SERVICE BULLETIN

Slide-Away Wheelchair Lift Retrofit Slide-Away Series Products Slide-Away Retrofit for Models with S/Ns 224597-Lower and S/Ns 224598-Above

RSB0001100

FIGURE 1: SLIDE-AWAY KIT COMPONENT LOCATIONS

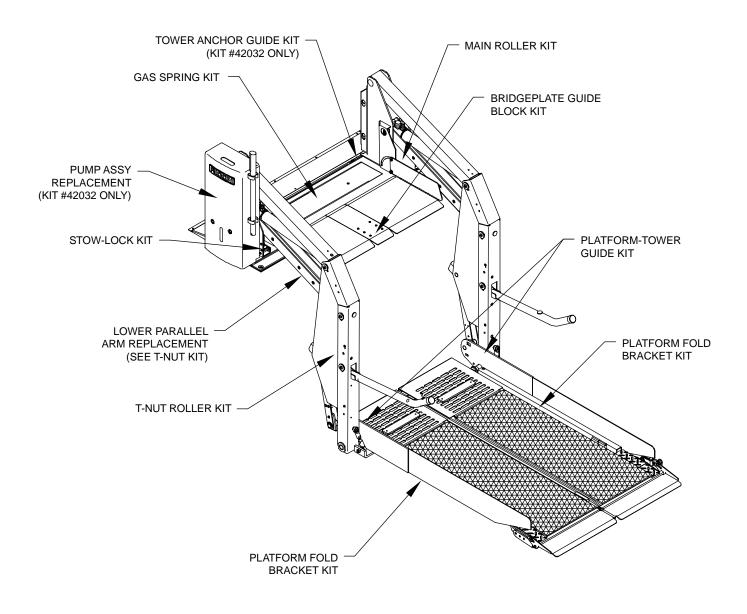
- A. Slide-Away Retrofit Kit #42031 for models with Serial Numbers 224598 and Above
- **Note:** This corrective action only affects models with serial numbers 224598 and above. This kit is only for replacement of the gas strut, slider cable keeper/half moon guide, stow-lock latch and assembly, t-nut, lower parallel arms, platform fold brackets, bridgeplate guide blocks and platform-tower guides. Refer to Figure 1.
 - 1. Inspect model serial number and unit to determine if retrofit kit is applicable.
 - 2. Ensure that the applicable kit includes all of the kits required before proceeding with retrofit.
 - 3. If the wheelchair lift has a model serial number 224598 and above then follow installation instructions (32ii416e) for Slide-Away Retrofit Kit #42031.
- Note: A separate Gas Spring Kit #36998 is included in this retrofit kit and can be ordered separately.

- **Note:** This corrective action only affects models with serial numbers 224597 and lower. This kit includes the same procedures as mentioned above with the addition of the tower anchor guides and replacement of the pump assembly. Refer to Figure 1.
 - 1. Inspect model serial number and unit to determine if retrofit kit is applicable.
 - 2. Ensure that the applicable kit includes all of the kits required before proceeding with retrofit.
 - 3. If the wheelchair lift has a model serial number 224597 or lower then follow installation instructions (32ii417e) for Slide-Away Retrofit Kit #42032.
- **Note:** A separate Gas Spring Kit #36998 is included in this retrofit kit and can be ordered separately.
